To All Lamborghini Dealers and Licensed Service Point
From Customer Service Department
Subject New bushings and supports for the rear torsion bar
Group 147.5.05.00
Date 17.11.2005
Pages 3

New bushings and supports for the rear torsion bar.

Murciélago coupe MY 02-03-04.

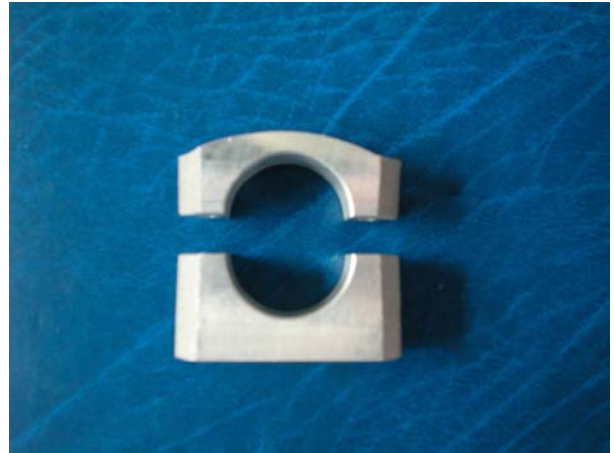
Old parts:

Old bushing for torsion bar p/n 400511324

Old support for torsion bar p/n 400411031A

New parts:

New bushing for torsion bar p/n 400511324C

New support for torsion bar p/n 400411031D

Important remark: In case of first replacement of old parts with the new ones, due to the different technical specifications of the new bushings and supports, it's mandatory to replace the complete kit (2 bushes + 2 supports) on the involved bar, even if only one of the old part is defective, because the new parts are not compatible with the old ones.
